TX0-LTR-0028

Subject: **Response to Request for Additional Information (Set 4) for the TRISO-X License Application**

Enclosure 1 - Geotechnical RAI Responses for the TRISO-X License Application

Attachment to Enclosure 1
 Revised License Figure 1-3: Plan View of Geologic Cross Sections

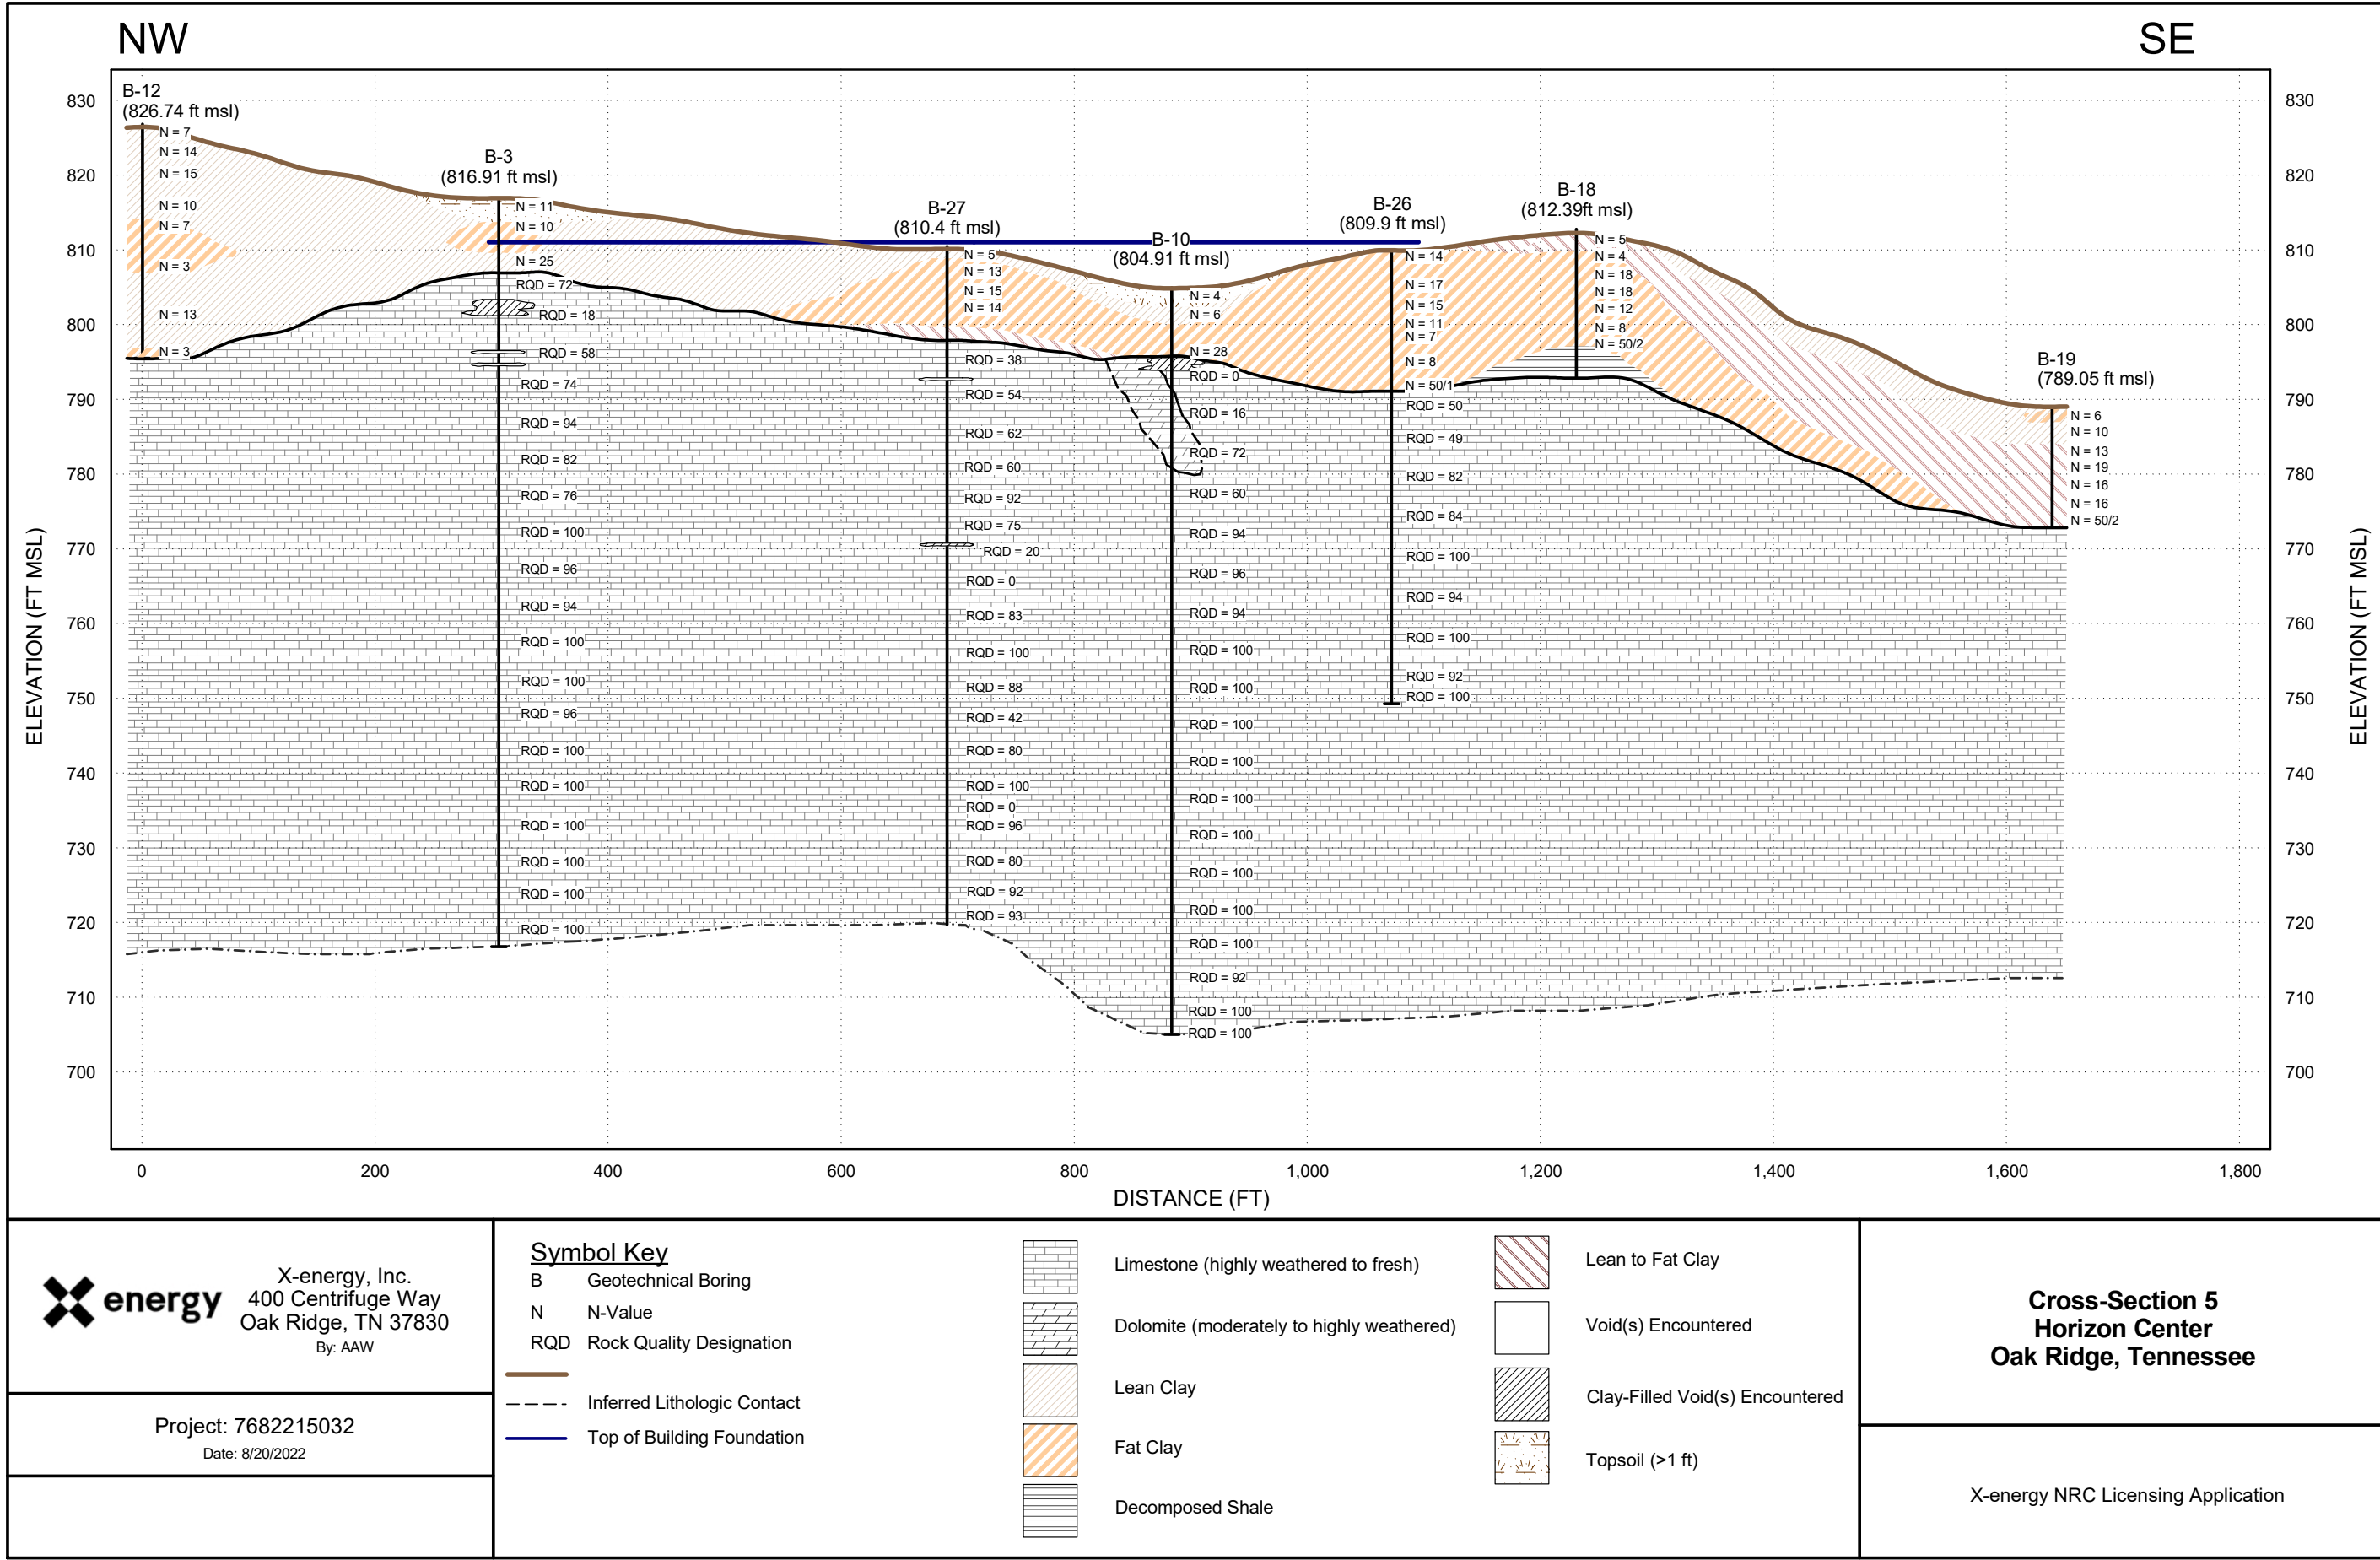
The locations of certain borings are unclear as to whether they are within or outside the footprint of the Process Building. For example, License Application (LA) Figure 1-5 (Cross Section 2) shows that Boring B-23 is outside the Process Building footprint whereas Figure 1-7 shows that B-23 is inside the footprint. In addition, the log of Boring B-3 given in Cross Section 1 (LA Figure 1-4) do not match with the log given in Cross Section 5 (LA Figure 1-8). All Rock Quality Designation (RQD) values are 54 in Cross Section 5. Additionally, the RQD values reported at deeper depths (e.g., below 720 ft elevation) of Boring B-23, shown in Cross Section 2 (LA Figure 1-5) and Cross Section 4 (LA Figure 1-7), do not match. Similarly, RQD values at deeper depths of Boring B-27 do not match in Cross Section 2 (LA Figure 1-5) and Cross Section 5 (LA Figure 1-8).

Provide an updated LA Figure 1-3 of the geotechnical boring locations superimposed on the footprint of the Process Building. Additionally, update the cross-sections provided in LA Figures 1-4 through 1-8.

License Chapter 1, Figure 1-3 (Plan View of Geologic Cross Sections) has been revised to show the boring locations superimposed on the footprint of the Process Building. Cross Sections depicted in License Chapter 1, Figures 1-4 through 1-8 have been revised to address the comments provided in RAI-1. License Chapter 1, Figure 1-7 (Cross-Section 4) depicts borings B-13 to B-22 in a two-dimensional format, viewing the cross section from the SW direction. Boring B-23, which physically does fall outside the Process Building footprint, is shown as falling within the footprint in Figure 1-7 because the cross section is viewed on a single plane, with no integration of depth.

License Chapter 1, Figures 1-3 through 1-8 will be revised as described above. Revised figures are included in the Attachment to Enclosure 1.

New License Figure 1-9

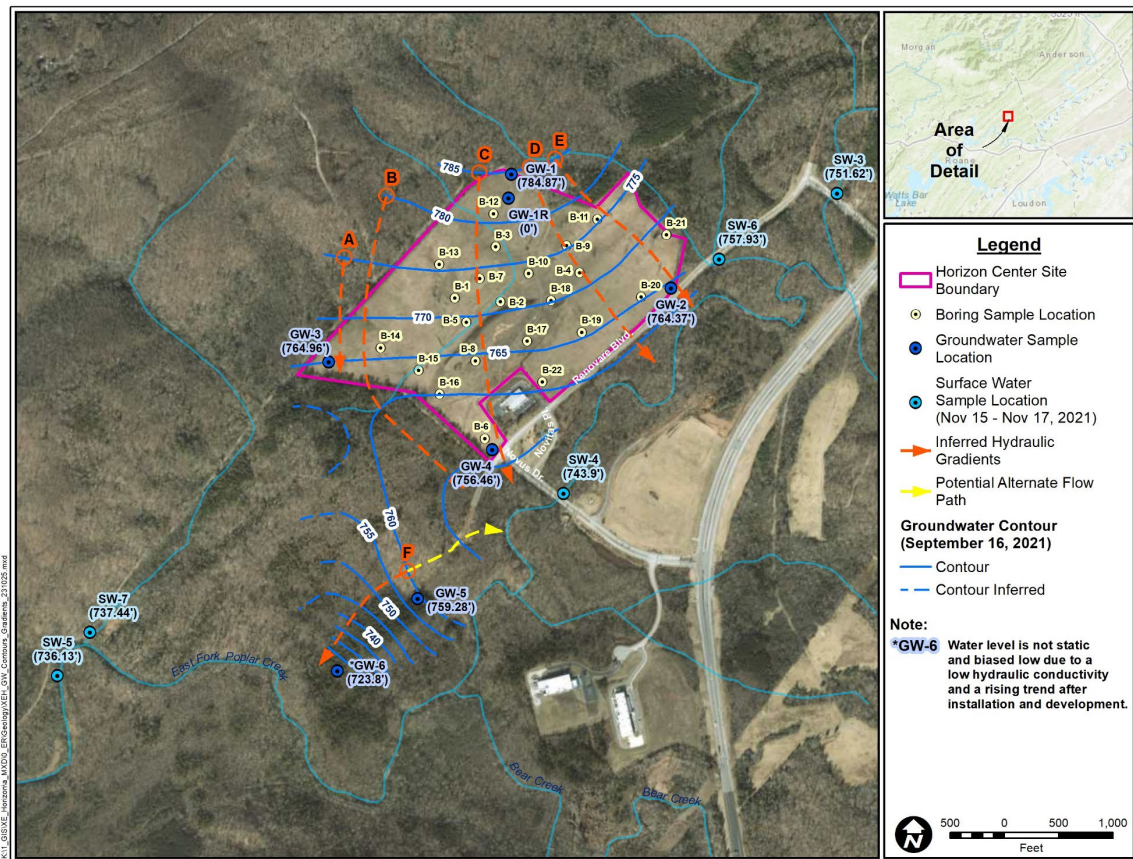
Section 1.1.1.3, “Hydrology,” in Revision 2 to Chapter 1 of the TRISO-X LA states that, “Groundwater elevation measurements and modeling indicate that groundwater generally flows in a southwest direction toward East Fork Poplar Creek. There are no known household, public, or industrial users of groundwater downgradient of the site.” However, both statements on flow direction and users of groundwater lack supporting evidence. While Figures 3.4.1-5 and 3.4.1-6 in the same LA document show a general flow direction towards the southeast, not the southwest, it is not clear where the terminus for the groundwater movement is. It is uncertain if the groundwater from HCS discharges to East Fork Poplar Creek or flows underneath since there are no groundwater monitoring wells on the other side of the creek. Therefore, it is unknown if there are household, public, or industrial users of groundwater downgradient of the site. This is especially true if the contour lines drawn in Figure 3.4.1-5 and 3.4.1-6 are correct. The contour lines between the groundwater monitoring wells GW-5 and GW-6 show a flow that is not discharging into the creek, but rather flowing parallel to it. However, the southwest corner of the figures, which includes the depression labeled as a sinkhole (see Development Area 5 in Figure 3 in DOE (2013)), suffers from a lack of data and any contour lines drawn in this area would be associated with a large uncertainty. For example, the flow direction from GW-5 shows a flow direction to the southwest in both figures; however, an inferred hydraulic gradient could show groundwater flowing to the northeast since the both figures show a 755-foot contour line to the northeast that is five feet below that of the measured head for GW-5

- Revise LA section 1.1.1.3, "Hydrology," to include an evaluation and a discussion pertaining to this new hydrologic data.

No wells were identified for data to support flow south of East Fork Poplar Creek. However, existing data was used to update the interpretation of groundwater flow and to provide supporting evidence of flow paths. Environmental Report Figures 3.4.1-5 and 3.4.1-6 will be revised (included in the Attachment to Enclosure 2) to show surface water elevations with respect to groundwater elevations, supporting groundwater discharge to East Fork Poplar Creek and not shallow groundwater flow beyond the creek. Environmental Report Figures 3.4.1-5 and 3.4.1-6 will also be revised to show that a groundwater divide exists during both drier and wetter periods near GW-5. Flow at the groundwater divide can occur from the south to the north, turning to the east locally near GW-5 and ultimately indicating discharge to East Fork Poplar Creek. Additionally, Figures 3.4.1-5 and 3.4.1-6 will be expanded to show the East Fork Poplar Creek turns to the north just south and west of GW-6 and that flow from south and west of GW-5 is toward East Fork Poplar Creek.

The revised Environmental Report Figures 3.4.1-5 and 3.4.1-6 will be added to the license as new License Figures 1-9 and 1-10, respectively.

The groundwater elevation noted at GW-6 during the summer in Figure 3.4.1-5 could be interpreted as groundwater flow beneath EFPC. However, the hydrograph for well GW-6 shows that the water level in summer was not static and on a very slow rising limb due to low hydraulic conductivity after installation and development. The groundwater elevation at GW-6 stabilized at an elevation of approximately 741 feet in February 2022 where it remained through the remainder of the monitoring program (Figure 3.4.1-4). A groundwater elevation of 741 feet at GW-6 and estimated EFPC surface water elevation of approximately 740 feet west of GW-6, based on surface water elevations from upstream of GW-6 at SW-4 (743.9 feet) and downstream of GW-6 at SW-5 (736.13 feet) supports discharge of groundwater to EFPC and not beyond.
